## **DISCUSSION**

## **IN THE DRAWINGS**

ANNOTATED DRAWING  
with AMENDMENT-C  
02 February 2005  
10/055,844

Fig. 4

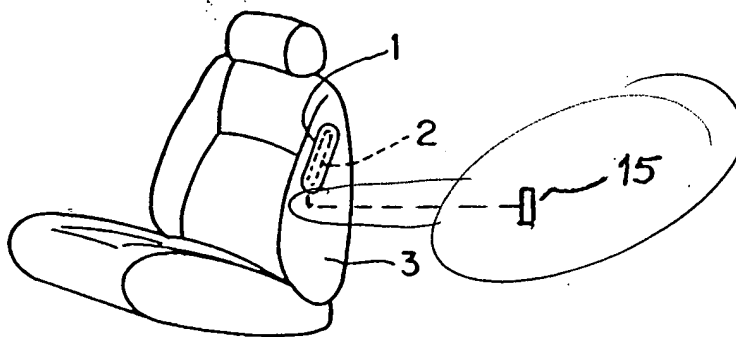
Applicant encloses herewith substitute drawing sheets for Figures 1, 2, 4, 5, 6 and 18-19. Figure 2 is modified to include a lead line between "a" and the arrow. Figure 4 has been modified to show the acceleration sensor 15. Figure 19 has been modified to change the reference number for the closed local circle region to be 6-0 so that it will not conflict with the use of reference numeral 6 in Figure 7.

In Figure 4, the acceleration sensor 15 has been added as requested by the Examiner.
